Report of the Trinity Parkway Advisory Committee

March 18, 2016

The Committee was asked to advise the Transportation Committee of the City Council on whether the latest findings by the Trinity Parkway Technical Team ("Technical Team") are consistent with the 20 project ideas originally presented in the Trinity Parkway Design Charrette Report ("Report"). The original Report and the work of the Technical Team had three primary objectives for the Parkway that were summarized to the City Council in April, 2015. They were to:

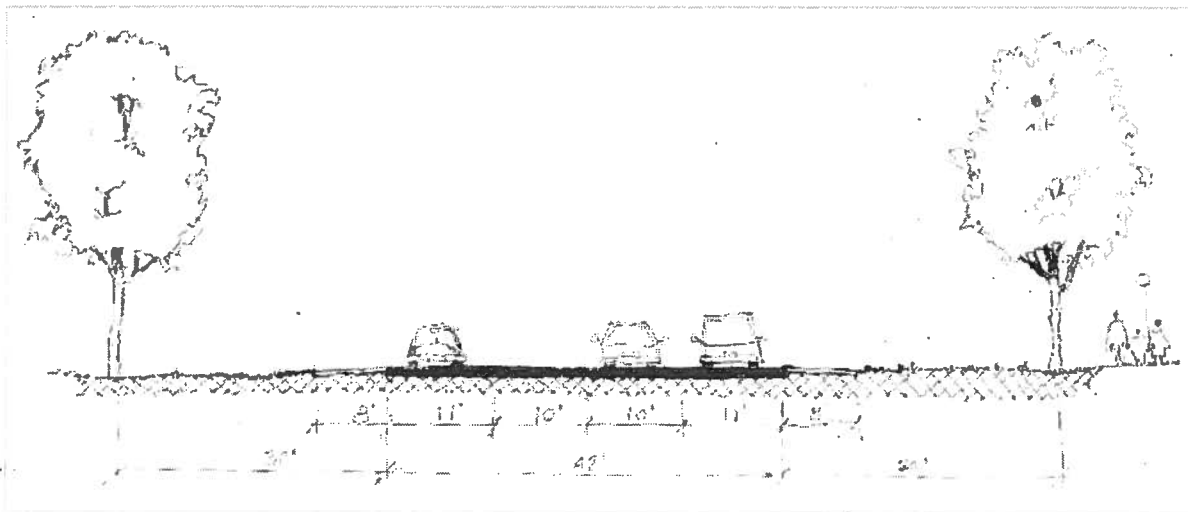
The meanders proposed in the Charrette Vision are the most prominent physical characteristic constraining the speed of the road. Tighter curves require drivers to maintain a lower speed, which is more appropriate to a park setting. The Technical Design has straightened the meanders, thus allowing for higher travel speeds.

Although the Technical Design's meanders ostensibly result in a design speed of 45 mph, further investigation of the geometry of the curves indicates that they would actually support much higher speeds. A design speed of 45 mph correlates with a curve radius of 1039 feet,³ yet the radii of most of the curves in the Technical Design are 2000 feet or more.⁴ To put this in perspective, a low-speed park-adjacent road like Turtle Creek Parkway has meanders with an average radius of 400 feet, resulting in a posted speed limit of 30 mph.

⁴ The radii of the meanders in the Technical Design are as follows: Set 1: Tangent - 2,000'; Set 2: 2,000' - 2,000'; Set 3: 1,750' - 1,600'; Set 4: 4,500' - 2,000'; Set 5: Tangent - 3,350'; Set 6: 2,000' - 2,000'; Set 7: 2,000' - 1,800'.

RECOMMENDATION: Direct the Technical Design Team to revise the meanders to reflect an anticipated 85th percentile speed of 40 mph and a posted speed of 35 mph.
